Access Compliance Report

Public Rights-of-Way

Intersection ID: 42366	Main Street: CARDINALS_NEST_DR	Cross Street: HERON_GLEN_DR	Location:	N
ADA ID: 8AA21883FA4A	Ramp Type: PerpDiag	Initial Pass/Fail: Pass	Overall Compliance: No	Severity Score: 25
Codes/Mitigation Info/Possible Solution		Field Measurements/Component Compliance

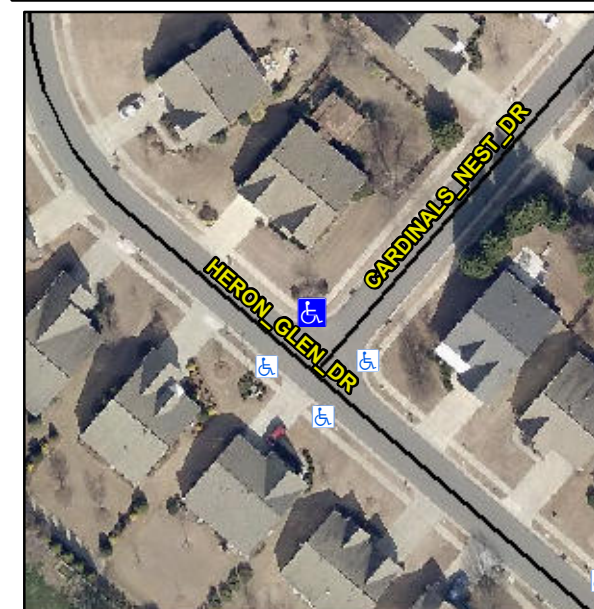
R304.2.2-Perp, R304.3.2-Para, R305, R302.7.2

Compliance	Description	Data	Compliance	Description	Data
N/A	Ramp Length (in)	46.0	Yes	Ramp Slope (%)	6.3
Yes	Ramp Width (in)	55.0	Yes	Ramp XSlope (%)	0.4
N/A	Flare Type LT	Sloped	N/A	Flare Type RT	N/A
N/A	Flare Slope LT (%)	7.3	N/A	Flare Slope RT (%)	5.2
N/A	Flare Traversable LT?	No	N/A	Flare Traversable RT?	No
Yes	Landing Length (in)	49.0	No	DWS Provided?	No
Yes	Landing Width (in)	72.0	N/A	DWS Contrast?	No
No	Landing Slope (%)	4.9	N/A	DWS Length (in)	N/A
Yes	Landing X Slope (%)	1.8	N/A	DWS Full Width?	No
N/A	Landing Curb? (Y/N)	No	N/A	DWS Offset (in)	N/A
N/A	Shared Landing?	No			
Yes	Gutter Ponding?	No	Yes	Gutter Slope (%)	1.1
No	Gutter Lip Ht (in)	1.5	Yes	Gutter X Slope (%)	0.1
N/A	Painted X Walk1?	No	N/A	Painted X Walk2?	No
	X Walk 1 Direction	To SW		X Walk 2 Direction	To SE
N/A	X Walk 1 Width (in)	N/A	N/A	X Walk 2 Width (in)	N/A
	X Walk 1 Slope (%)	2.4		X Walk 2 Slope (%)	2.2
	X Walk 1 X Slope (%)	2.7		X Walk 2 X Slope (%)	2.7

Remove & Replace Curb Ramp With Two New Directional Ramps or Equivalent. Grind Gutter Lip.
